Plug and Abandonment Procedure
for
DJR Operating, LLC
Bisti Gallup 22-2
API # 30-045-34209
NW/NE, Unit B, Sec. 22, T25N, R12W
San Juan County, NM

Re: Permanent Abandonment
Well: Bisti Gallup 22 Com 2

CONDITIONS OF APPROVAL

BLM FLUID MINERALS Geologic Report

Proposed Wellbore P&A Diagram

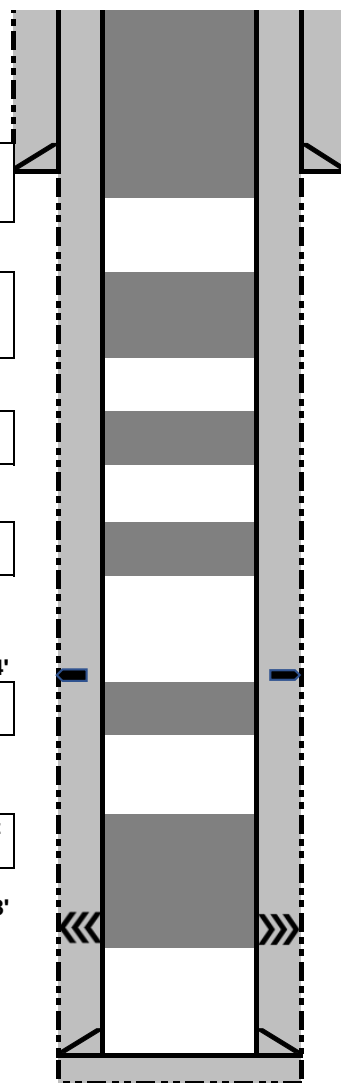
1. Plugging operations authorized are subject to the attached "General Requirements for Permanent Abandonment of Wells on Federal and Indian Lease."
2. Farmington Office is to be notified at least 24 hours before the plugging operations commence (505) 564-7750.
3. The following modifications to your plugging program are to be made:
 - a) Adjust Plug 1 so that the balance plug will be from 4988 to 4673 feet. 50 feet below the bottom perforation at 4938 feet.
 - b) Adjust or lengthened Plug 3 to cover BLM pick for the top of the Mesa Verde (Cliff House) pick at 1976 feet.
 - c) Plug 5 should be brought up to 500 feet to cover the BLM Ojo Alamo pick at 550 feet.

You are also required to place cement excesses per 4.2 and 4.4 of the attached General Requirements.

- BLM picks for the tops of the Gallup, Cliff House/Mesaverde and Chacra formations vary from operator picks. See recommended plug adjustments below.
- Bring the top of Plug #3 to 1812' to cover BLM pick for the top of the Cliff House/Mesaverde.
- Bring the top of Plug #4 to 1415' to cover BLM pick for the top of the Chacra.
- Log analysis of reference well #2 indicates the Nacimiento and Ojo Alamo sands investigated likely contain fresh water ($\leq 5,000$ ppm TDS). P&A procedure has adequate plugs to protect any freshwater sands in this well bore.
- Gallup perforations @ 4682' – 4854'.
